**REVIEW OF A CONCEPTUAL MODEL AND
EVIDENCE FOR TECTONIC CONTROL OF
THE GROUND-WATER SYSTEM IN THE
VICINITY OF YUCCA MOUNTAIN, NEVADA**

REVIEW OF A CONCEPTUAL MODEL AND EVIDENCE FOR TECTONIC CONTROL
OF THE GROUND-WATER SYSTEM IN THE VICINITY OF
YUCCA MOUNTAIN, NEVADA

U.S. Department of Energy
Yucca Mountain Project Office
Las Vegas, Nevada
July, 1989

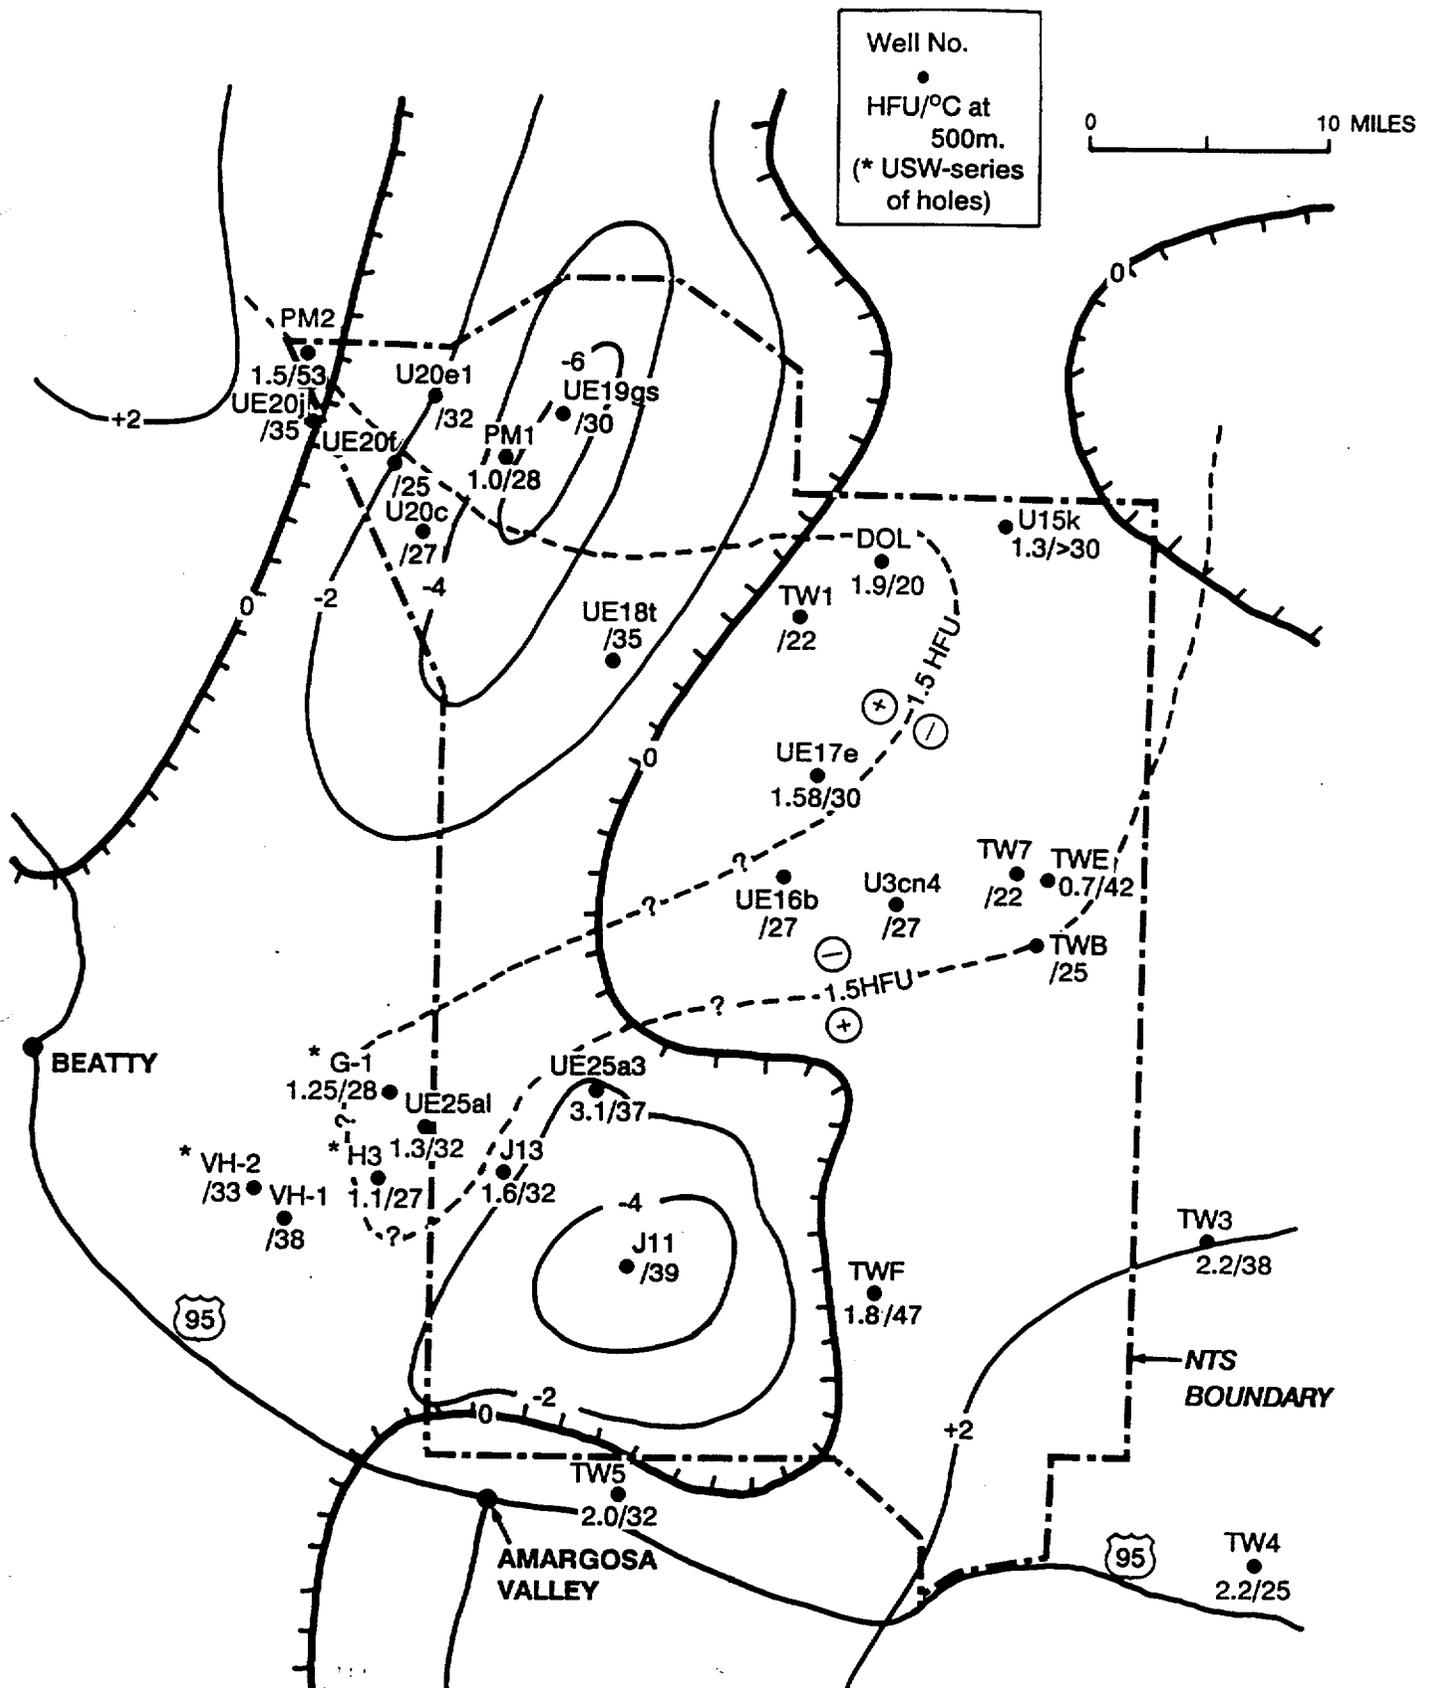
The author proposes (Pages 4-19 and 4-20) that increased heat flow and relatively high subsurface temperature (at a reference depth of 500 m) are clearly associated with low-velocity anomalies in the southwestern Nevada Test Site and Pahute Mesa areas. A map combining the velocity and temperature data was prepared by the reviewers as a visual test of the proposed correlation (Figure II.C-1). This map shows contours of the teleseismic P-wave departures (in percent) from the regional average arrival times, visually transferred from Plate 3.3.1-1 to the larger scale of Plate 4.6.2-1. The reviewers recognize that the contour map by Monfort and Evans (1982) is based on limited control, and that the scale of phenomena for residuals and heat flow may involve different regions of the crust. In spite of these problems, we continue in order to evaluate the author's conclusions.

The borehole data show calculated heat flow values and temperatures at a constant depth of 500 m below the surface. For holes in which temperatures were not actually measured at the 500-m depth, they were extrapolated from the logged intervals. The Pahute Mesa holes were re-plotted from Blankennagel and Weir (1973), as Sass and Lachenbruch (1982) had plotted them about 7 km north of their actual locations. The southward translation tends to strengthen rather than weaken the author's proposed correlation.

The manuscript (Page 3-21) associates the relatively higher heat flow values in the exploratory borehole UE25a-3 and wells TW3, TW4, TW5 and TWF with the negative velocity residual anomaly located in the southwestern corner of the Nevada Test Site. Inspection of Figure II.C-1 clearly shows that four of these holes are located across the zero contour (i.e., the locus of regionally average P-wave velocity) in the area of greater velocity. Holes TW3 and TW4 (both 2.2 HFU) are located on or across the +2 percent velocity residual contour line. The greatest heat flow (3.1 HFU at UE25a-3) that has been reported in southern Nevada (Sass et al., 1980; Sass and Lachenbruch, 1982;

Figure II.F-1. Hydraulic potentials plotted against depths of isolated intervals, composite open-hole water levels, and identified permeable zone for deep drillholes at Pahute Mesa, Nevada Test Site. Drawn from data in Blankennagel and Weir, 1973, Table 7.

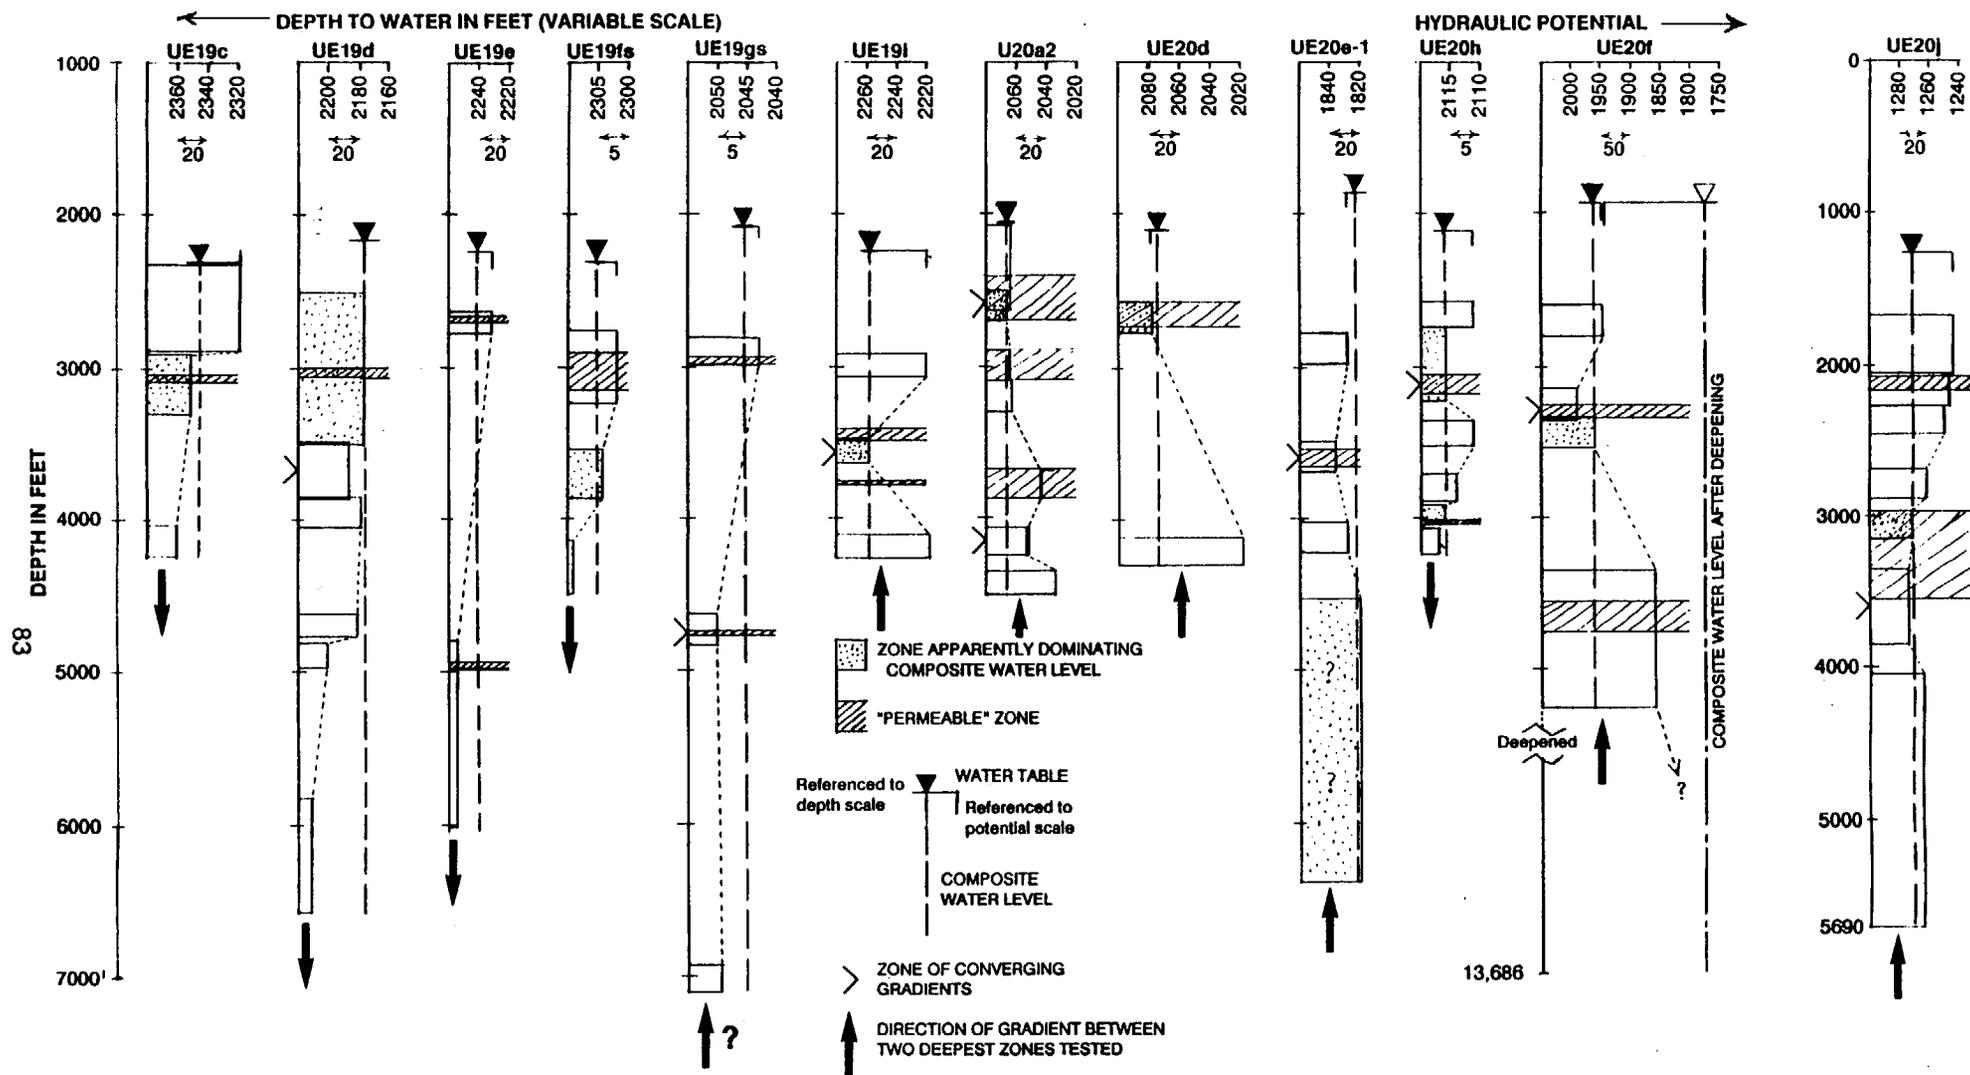
Table II.F-1 is a somewhat reorganized version of the Blankennagel and Weir (1973) data, reproduced in the manuscript as Plate 4.4-1. Directions of hydraulic gradient between pairs of tested zones have been added (arrows), as have "pointers" (<) at intervals toward which flow converges both downhole and uphole. A similar scheme is basic to the structure of Figure II.F-1. The potentiometric levels of the individual test zones are represented by the width, increasing to the right, of rectangles of which the top and bottom define the vertical interval that was isolated. The open-hole water level, representing the composite head, is shown by a dashed vertical line referenced to the potentiometric scale (i.e., increasing head to the right). The

apparent water table, estimated as the head in the shallowest zone tested, is referenced to the depth scale by a horizontal line emphasized with a darkened triangle and is referenced to the potentiometric scale with a short vertical line. Study of Figure II.F-1 is arduous but fruitful. It shows:

Figure II.G-1. Relation of pressure and injection rate during injection tests in USW H-3. Curve-type designation is from the draft manuscript under review. Adapted from Thordarson et al., 1985.

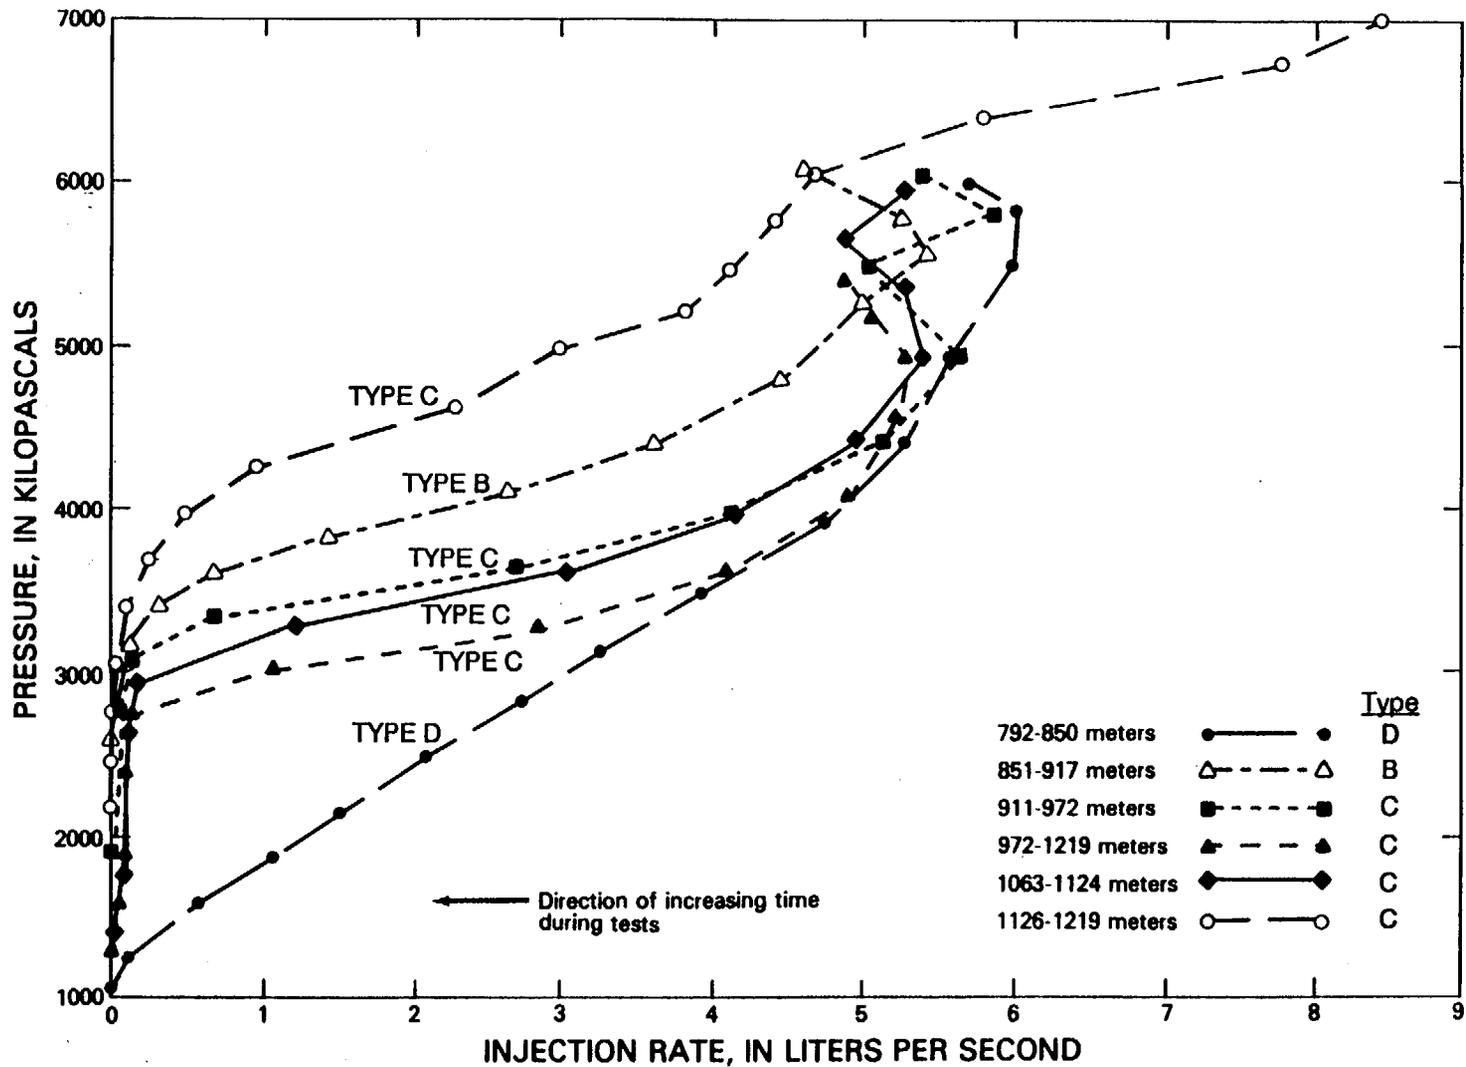
For purposes of testing the concept against actual field results, data from the slug tests in USW H-3 (Thordarson et al., 1985) are reproduced here in Figure II.G-1. The data are comparable to those presented in the constitutive relationship, as injection rate is proportional to slug velocity, but the axes are oriented differently and both are arithmetic. The manuscript classified each of these tests in one of three (type B, C, or D) of the four types shown on Plate 4.7.4-3. These designations are shown on Figure II.G-1.

Significantly, there were no curves classified by the author as type A in the test results from USW H-3; all were considered to show coupling of fracture dilation to fluid pressure. Note on the legend of Figure II.G-1 that the most "relaxed" state of stress is assigned to the shallowest zone tested, the least "relaxed" to the zone immediately below, and the intermediate state to the four deeper zones. However, proximity to failure is a function not only of the state of stress, but also of the mechanical properties of the rock. There is no apparent lithologic control: the upper three zones tested are in the Tram Member of the Crater Flat Tuff, described in Thordarson et al. (1985) as "mostly partially welded, devitrified"; the deepest test was in "partially welded, partially zeolitic(?) and argillic(?)" Lithic Ridge Tuff; the next-to-deepest zone spanned the lower Tram and upper Lithic Ridge and an intervening bedded tuff of 9 m thickness; the large-interval test (972 to 1,219 m) spanned the two deepest tested zones as well as the otherwise untested interval from 972 to 1063 m (i.e., it included approximately equal sections of Tram and Lithic Ridge and the bedded tuff). Analysis of geophysical logs (Thordarson et al., 1985) showed the Lithic Ridge Tuff (type C test) to be more porous than the average, the second-shallowest zone (851 to 917 m; type B test) to have the least percentage of porous rock, and the rocks in the intervals 792 to 850 m, 911 to 972 m, and 1,063 to 1,124 m (types D, C, and C, respectively) to have intermediate percentages of porous rock. The test (type C) spanning 972 to 1,219 m ranks second-highest in percent of porous rock. There is no apparent correlation of type designation to either stratigraphy or to porosity, making highly suspect the interpretation that adjacent zones contrast strongly in their susceptibility to failure.

Test interval 1,126 to 1,219 m in USW H-3 (Figure II.G-1) is classified as type C in the manuscript. The rate of decline of injection rate decreases with the decline of pressure from 7 to about 5.5 MPa. This requires, according to the constitutive relationship, that the Griffith criterion be about 6 MPa. Another possible explanation is that the flattening of the curve in the range of 7 to 5.5 MPa represents the transition from turbulent to laminar flow. However, all of the curves are erratic in the first minute of recovery (Thordarson et al., 1985, Figure 10), occurring at pressures generally above 5 MPa, and they probably are exhibiting inertial effects and oscillatory reaction to the sudden applications of high pressures. Hydrofracturing at the highest pressures also cannot be ruled out. Below about 3 MPa the measured pressure-transient behavior of the tests approaches that of the Cooper et al. (1967) type curves, and indicates that the Griffith

criterion is more likely about 3 MPa. In fact, the curves on Figure II.G-1, excluding that for 792 to 850 m, all exhibit a convergence within the range of about 2.8-3.5 MPa at an injection rate of about 0.1 L/s. Below the convergence pressure, the curves deflect sharply, and the decline of head continues at a very small rate. This strongly indicates the closure of fractures at this approximate fluid pressure, as stated by Thordarson et al. (1985). Between about 5 MPa and about 3 MPa, the type B and type C curves are similar in shape, which for previously fractured rock suggests a simple dilational relation between fluid pressure and fracture permeability.

The curve on Figure II.G-1 for the interval 792 to 850 m, designated type D in the manuscript, is obviously different. If the designation is correct, then 1.3 MPa is larger than the closure stress on a pre-existing fracture oriented perpendicular to the axis of the least principal stress, indicating a very small normal stress. On the recovery curves in the more usual format, this test (Plate 4.7.4-6, top) did not exhibit the characteristic stepped recovery evident in the other curves obtained from testing in USW H-3 (Plates 4.7.4-6, bottom; 4.7.4-6a and 4.7.4-6b). Instead, the recovery provided a fairly good match to theoretical type curves. This suggests either that the interval has dominantly interstitial permeability or that it is pervasively fractured and behaves almost as an equivalent porous medium of moderate permeability. The curve for this test on Figure II.G-1 demonstrates a linear relationship of injection rate to pressure in the time period 1.5 to 10 minutes, when the recovery was 90 percent complete. Thordarson et al. (1985) used this to interpret that the hydraulic properties were independent of injection pressure.
